**ERRATA TO THE  
2003 INTERNATIONAL RESIDENTIAL CODE**

**Errata to the Third Printing, November 2003**  
(Updated December 16, 2003)

**FIGURE R403.3(2)  
AIR-FREEZING INDEX  
AN ESTIMATE OF THE 100-YEAR RETURN PERIOD**

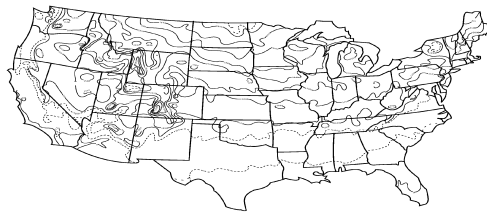
**FIGURE R403.3(2) AIR-FREEZING INDEX AN ESTIMATE OF THE 100-YEAR RETURN PERIOD**

Replace figure and revise the "3000" contours in NY, VT, NH and Maine to read "2000".
